AMENDMENT 11

AMENDMENT 11

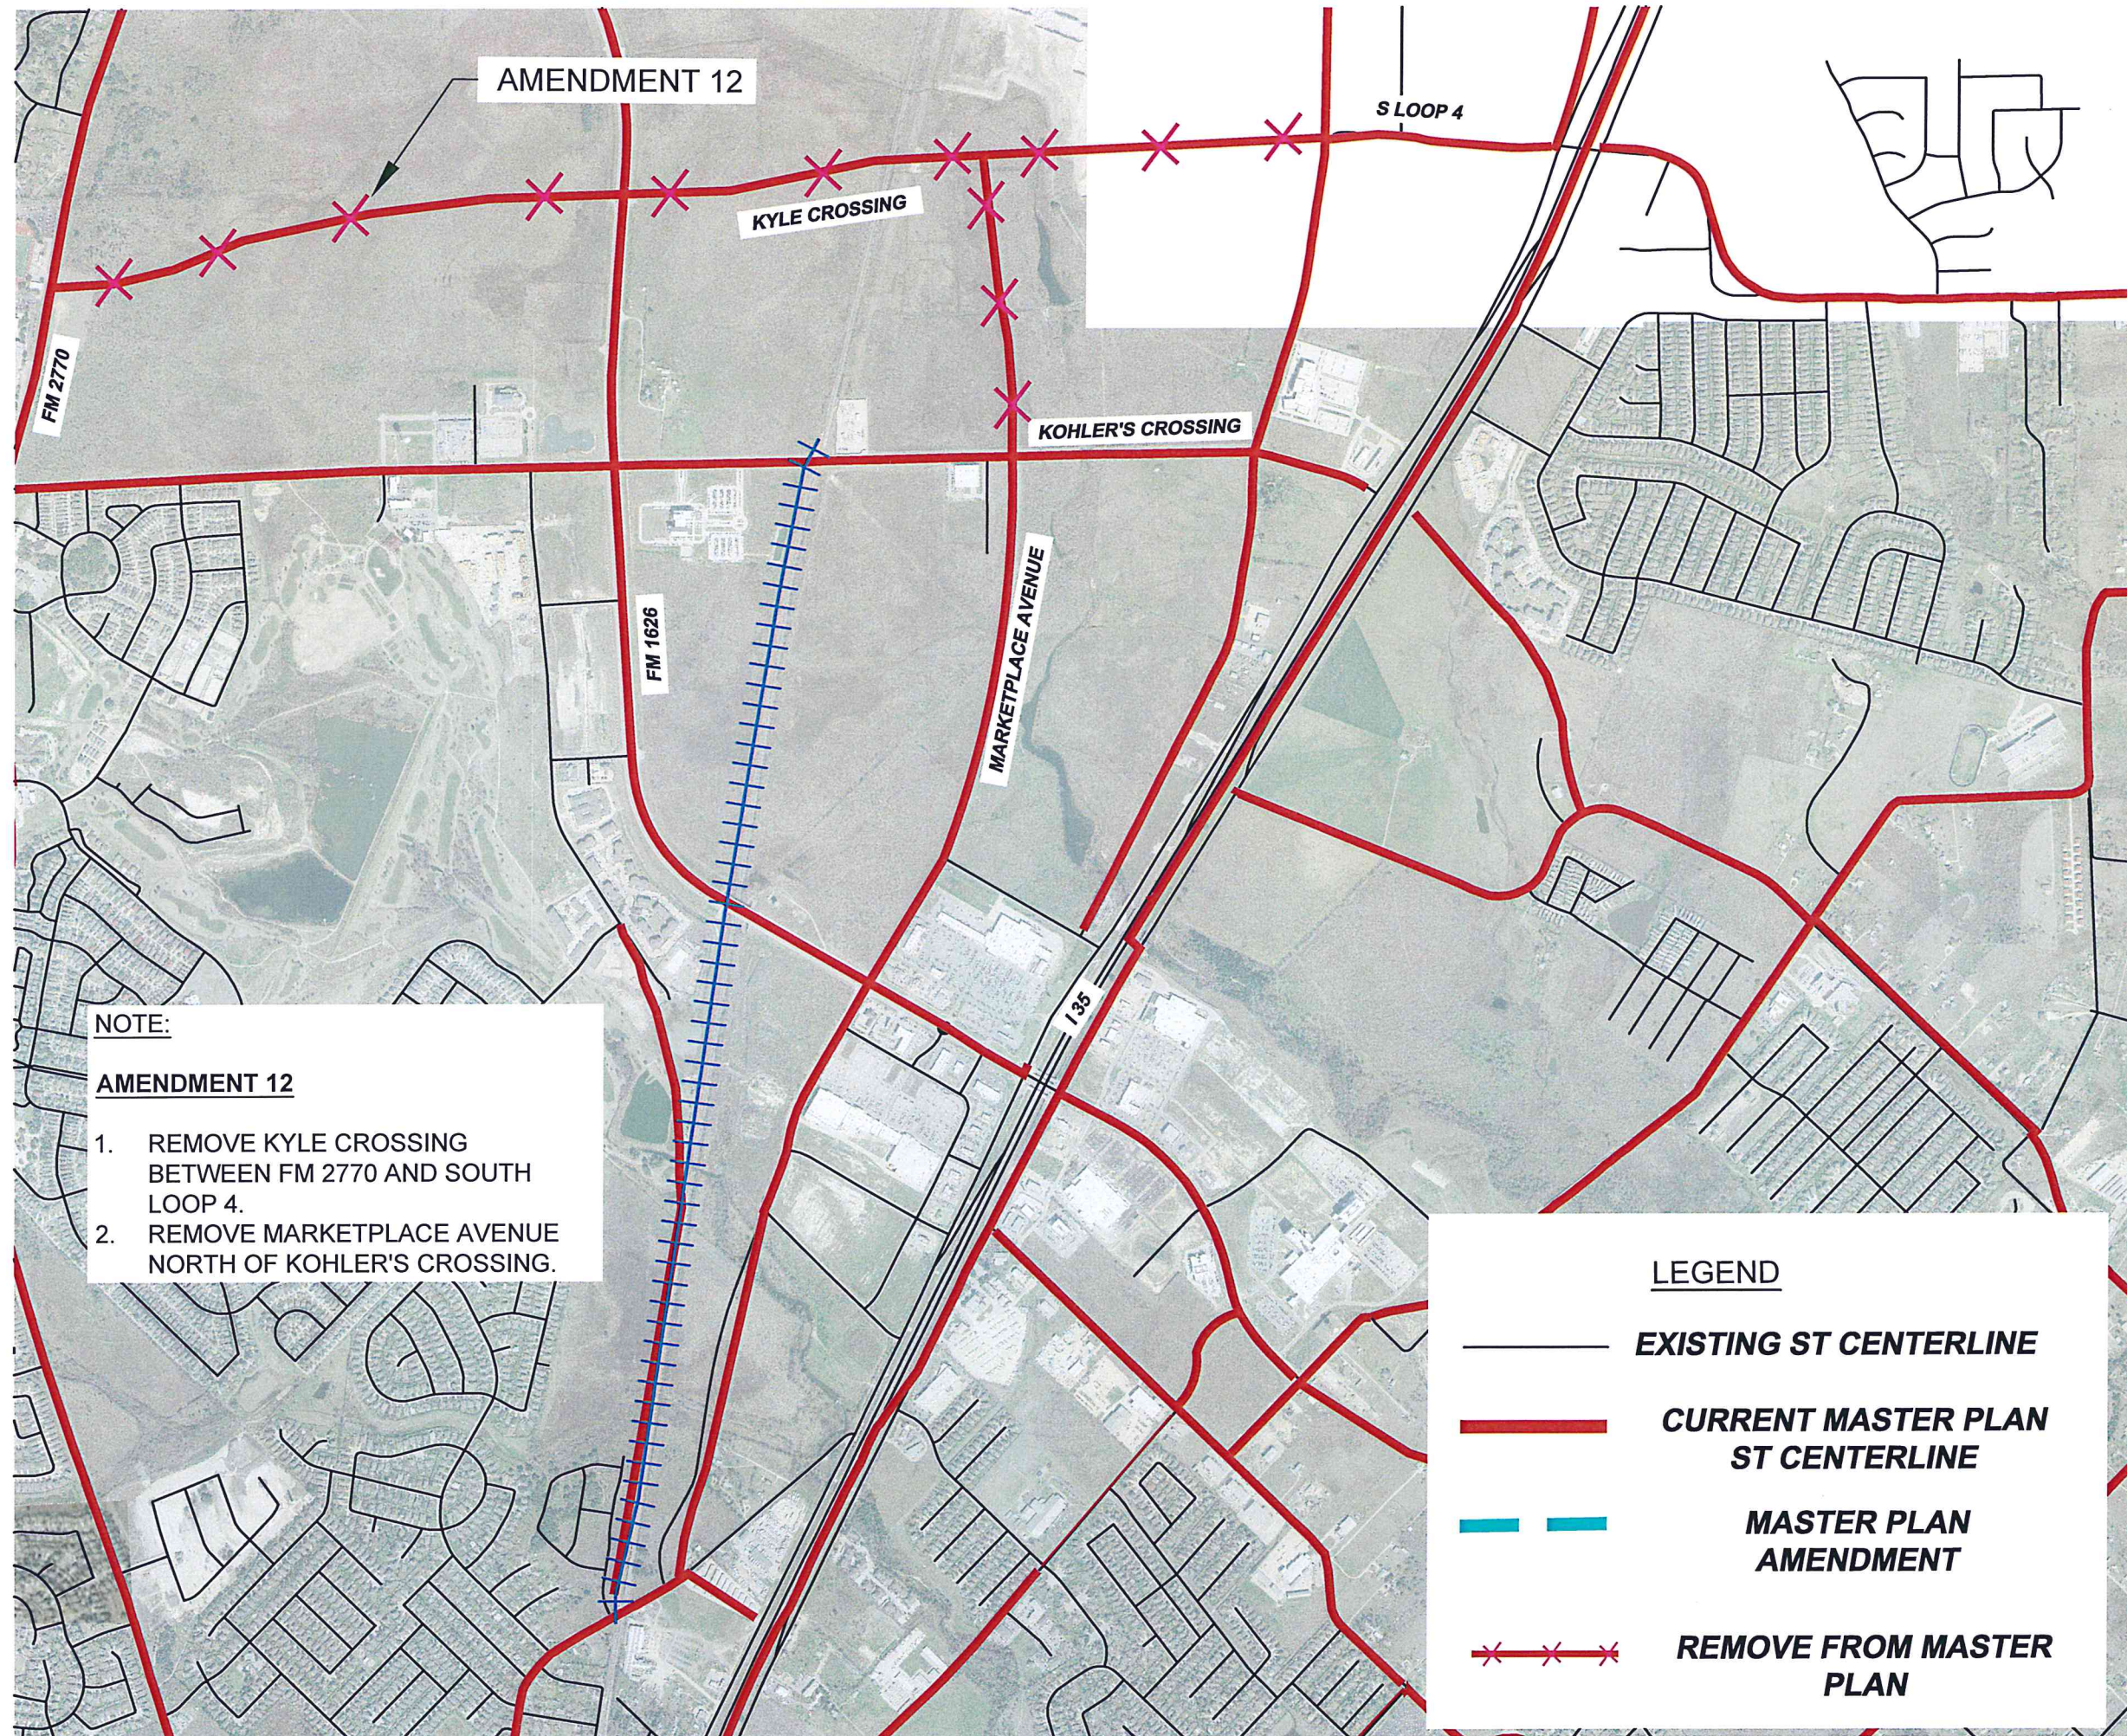
1. REMOVE PROPOSED PLUM CREEK ROAD BETWEEN RM 150 AND BUNTON/GRISTMILL ROAD.
2. REPLACE THE CONNECTION WITH NEW ALIGNMENT.

AMENDMENT 12

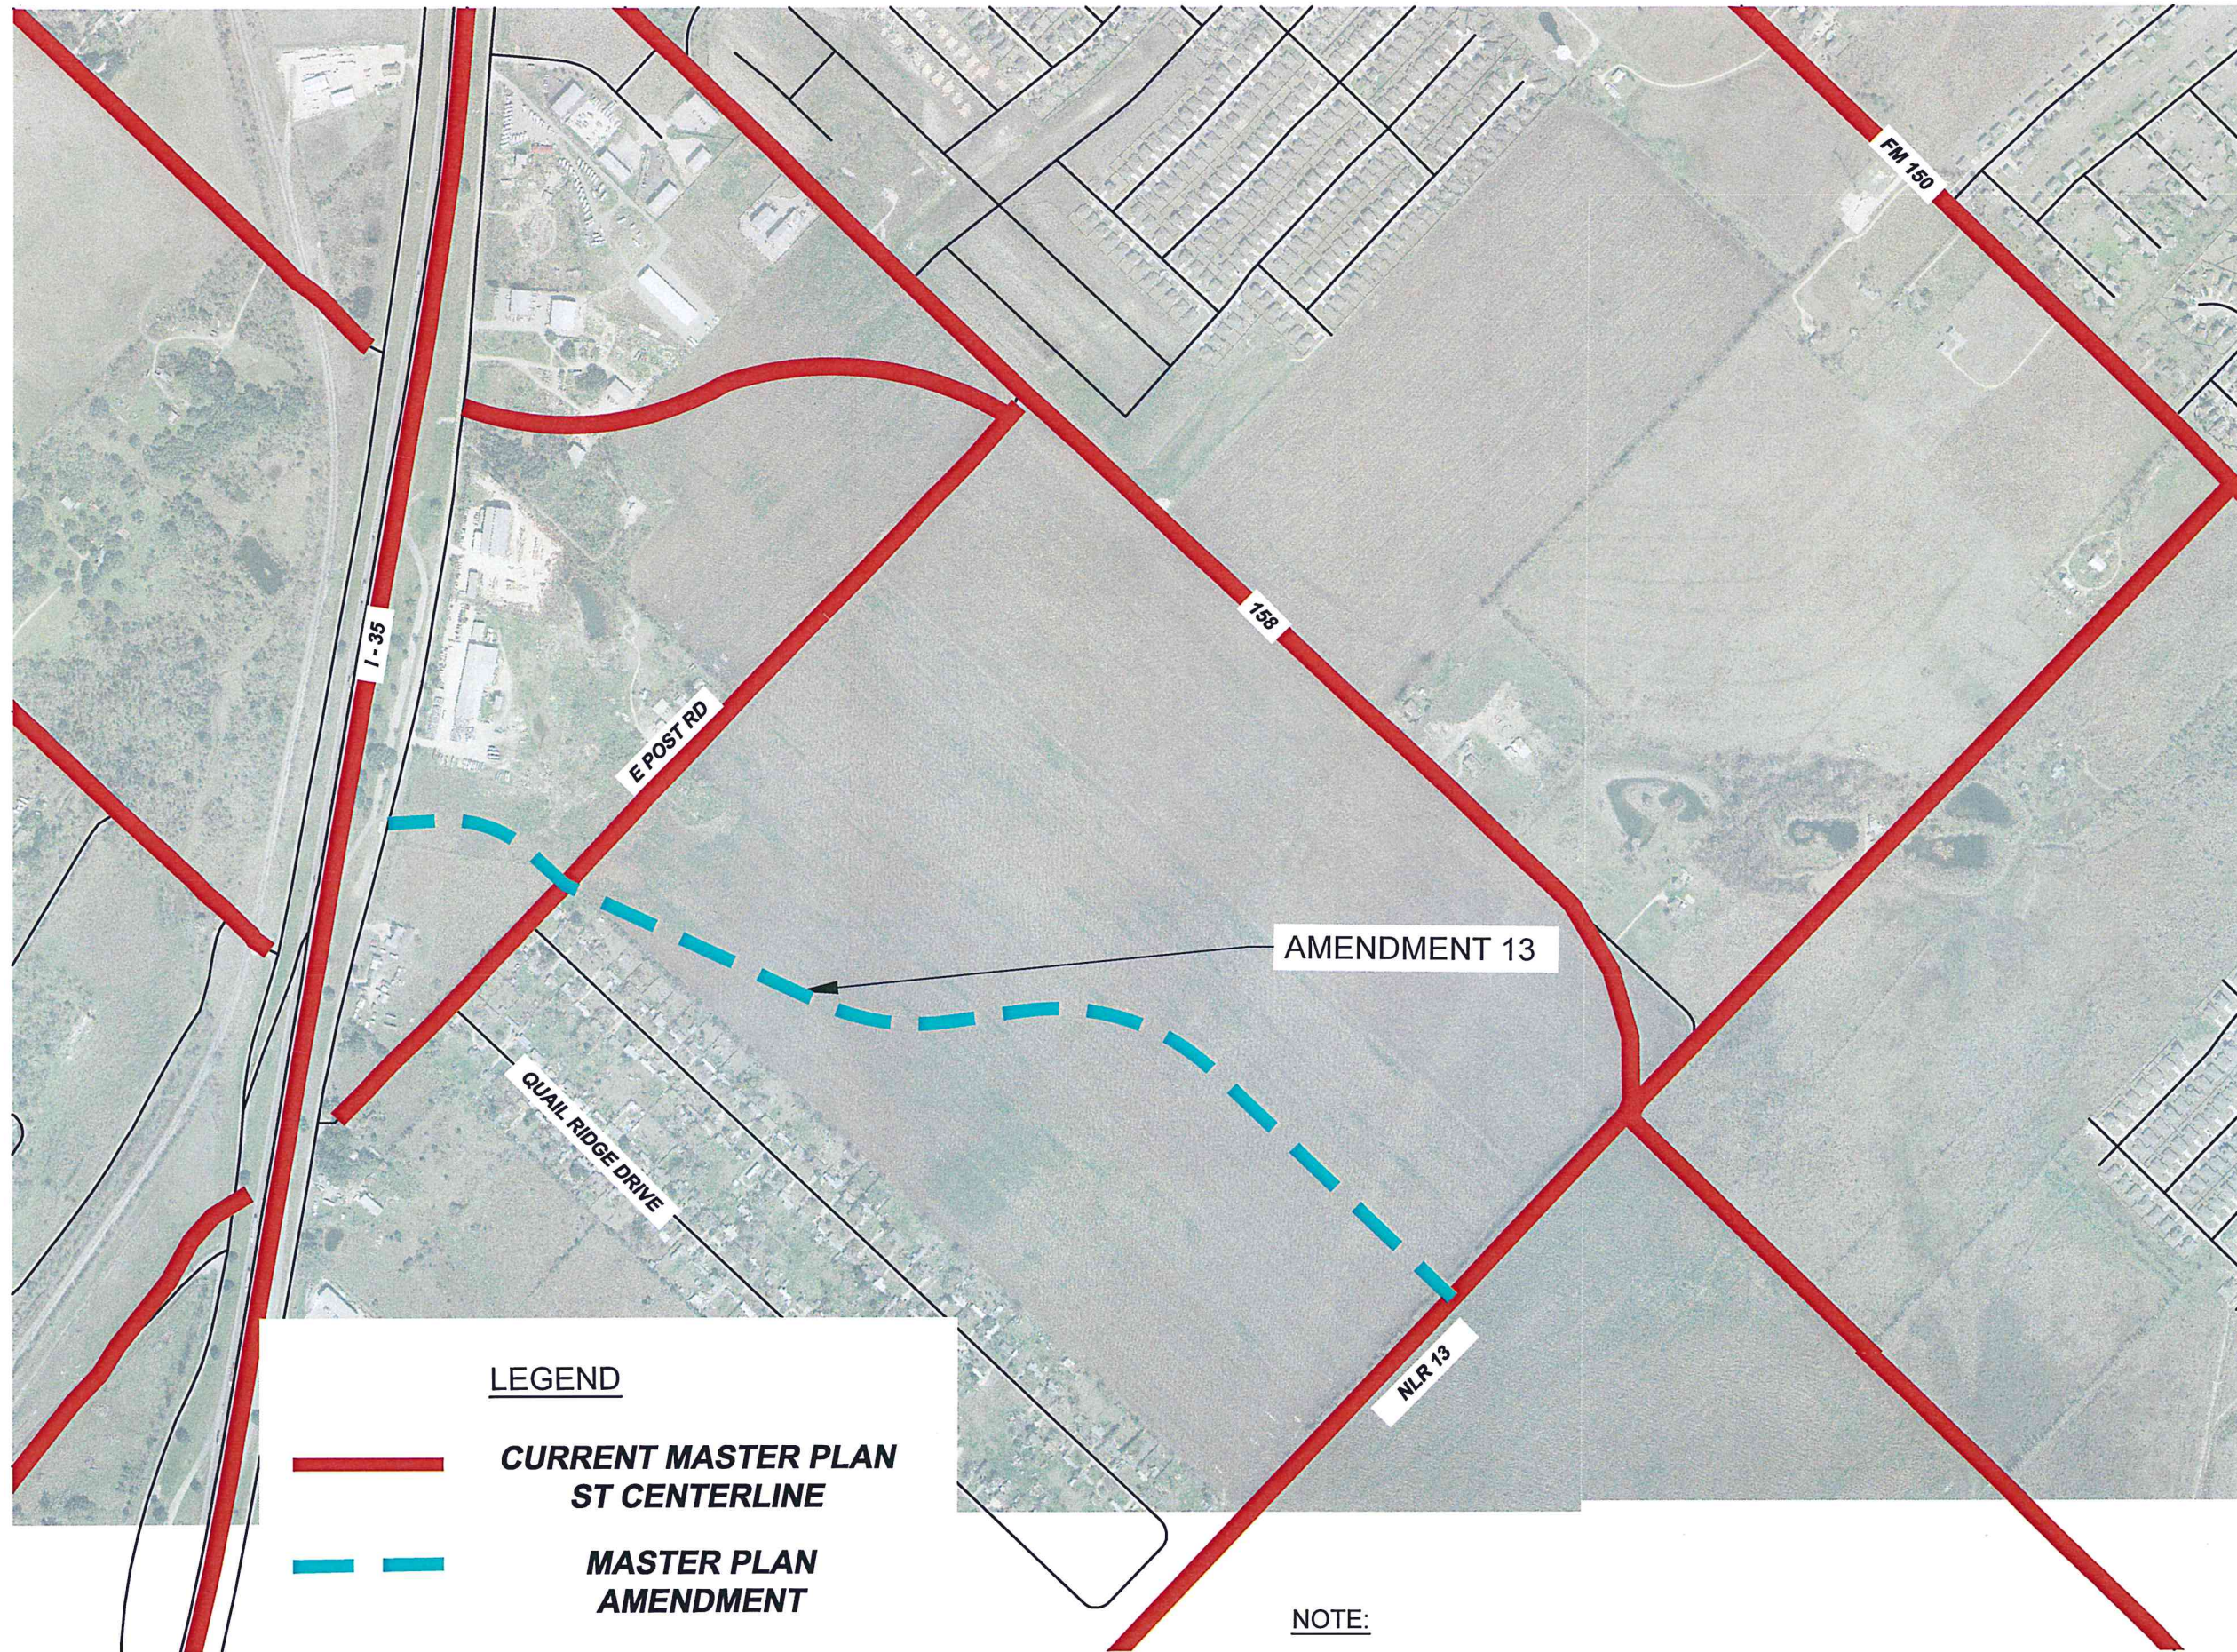
1. REMOVE KYLE CROSSING BETWEEN FM 2770 AND SOUTH LOOP 4.
2. REMOVE MARKETPLACE AVENUE NORTH OF KOHLER'S CROSSING.
